Terminal Block Wiring Gate

August 20, 2012

Issue Severity:	Product Affected:
<input type="checkbox"/> High: Act immediately	<ul style="list-style-type: none">• B820• ENKIT-SDI2
<input type="checkbox"/> Medium: Recommended action(s) described below.	
<input checked="" type="checkbox"/> Low: Advisory

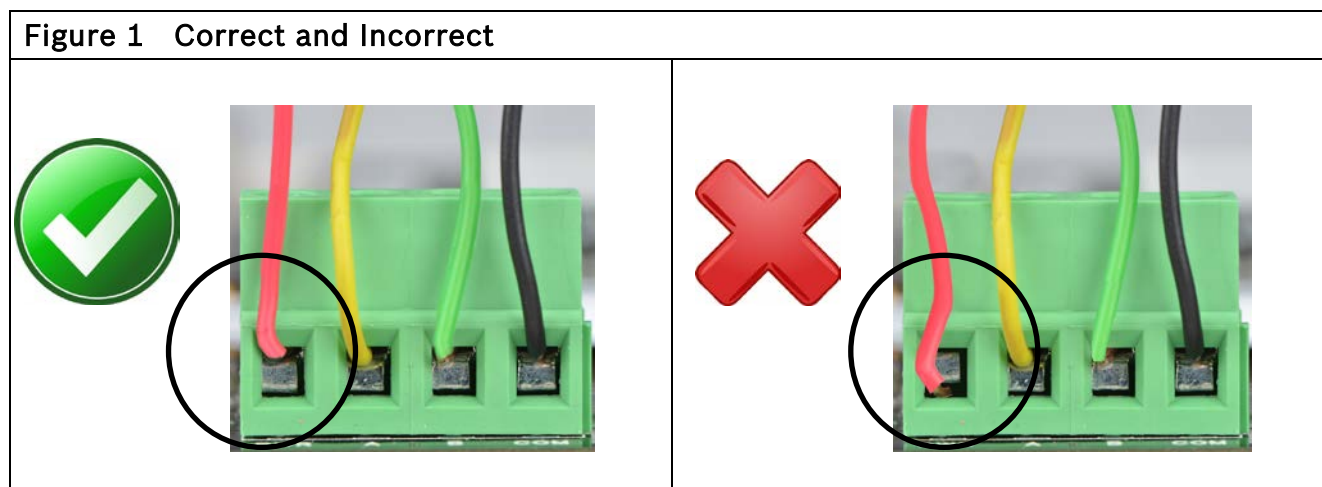
Incorrect insertion of the wire below the gate of the terminal block can cause a short on the board, overheating, and component failure. Based upon control panel programming, the device is reported as missing by the control panel.

Verify the wiring is inserted correctly into the terminal block gate to avoid the issue. Refer to *Figure 1* below.

The design of the B820 terminal block is being updated to further reduce the possibility of this wire insertion error.
